# Access Compliance Report

## Public Rights-of-Way

### (Curb Ramps)

Intersection ID: 10014519	Main Street: UNIVERSITY_POINTE_BV	Cross Street: N/A	Location: NE
ADA ID: D668D61FEE43	Ramp Type: Perp	Initial Pass/Fail: Fail	Overall Compliance: No
			Severity Score: 21.25

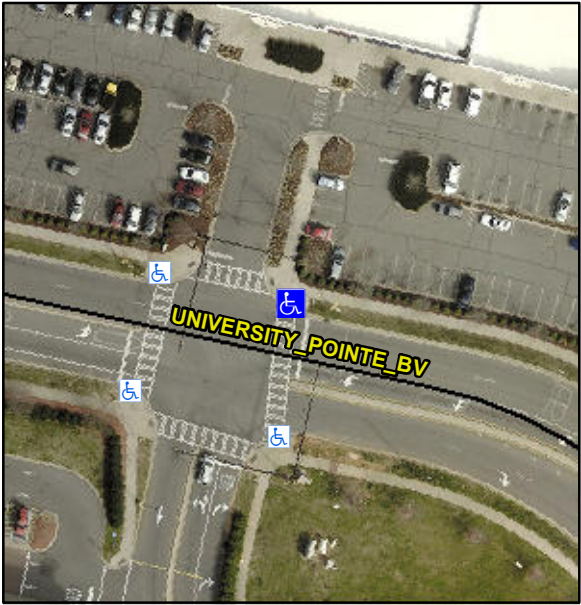
Codes/Mitigation Info/Possible Solution			Field Measurements/Component Compliance		
	Possible Solutions:		<b>Compliance</b>	<b>Description</b>	<b>Data</b>
	<b>Remove &amp; Replace Entire Ramp.</b>		<b>No</b>	Ramp Length (in)	<b>96.0</b>
			<b>No</b>	Ramp Width (in)	<b>43.0</b>
			<b>N/A</b>	Flare Type LT	<b>N/A</b>
			<b>N/A</b>	Flare Slope LT (%)	<b>N/A</b>
			<b>N/A</b>	Flare Traversable LT?	<b>N/A</b>
			<b>N/A</b>	Landing Length (in)	<b>N/A</b>
			<b>N/A</b>	Landing Width (in)	<b>N/A</b>
			<b>N/A</b>	Landing Slope (%)	<b>N/A</b>
			<b>N/A</b>	Landing X Slope (%)	<b>N/A</b>
<p>Surveyor Notes:</p> <p><b>N/A</b></p> <p>PROW/ADA:</p> <p><b>Not Found, R304.5.1, R304.2.2</b></p>			<b>N/A</b>	Flare Type RT	<b>N/A</b>
			<b>N/A</b>	Flare Slope RT (%)	<b>N/A</b>
			<b>N/A</b>	Flare Traversable RT?	<b>N/A</b>
			<b>N/A</b>	DWS Provided?	<b>N/A</b>
			<b>N/A</b>	DWS Contrast?	<b>N/A</b>
			<b>N/A</b>	DWS Length (in)	<b>N/A</b>

<b>N/A</b>	DWS Full Width?	<b>N/A</b>
			<b>N/A</b>	DWS Offset (in)	<b>N/A</b>
			<b>N/A</b>	Gutter Ponding?	<b>N/A</b>
			<b>N/A</b>	Gutter Lip Ht (in)	<b>N/A</b>
			<b>N/A</b>	Painted X Walk1?	<b>Yes</b>
				X Walk 1 Direction	<b>To S</b>
			<b>N/A</b>	X Walk 1 Width (in)	<b>99.0</b>
				X Walk 1 Slope (%)	<b>4.2</b>
				X Walk 1 X Slope (%)	<b>1.1</b>
			<b>N/A</b>	Ramp inside XWalk1?	<b>Yes</b>
				Road Slope (%)	<b>N/A</b>
				Road X Slope (%)	<b>N/A</b>
			<b>N/A</b>	Any Obstructions?	<b>N/A</b>
				Obstruction Type	
Total Cost:					
		<b>\$ 1850.00</b>			
			<b>N/A</b>		<b>N/A</b>
			<b>Yes</b>	Surface Condition? (G/P)	<b>Good</b>
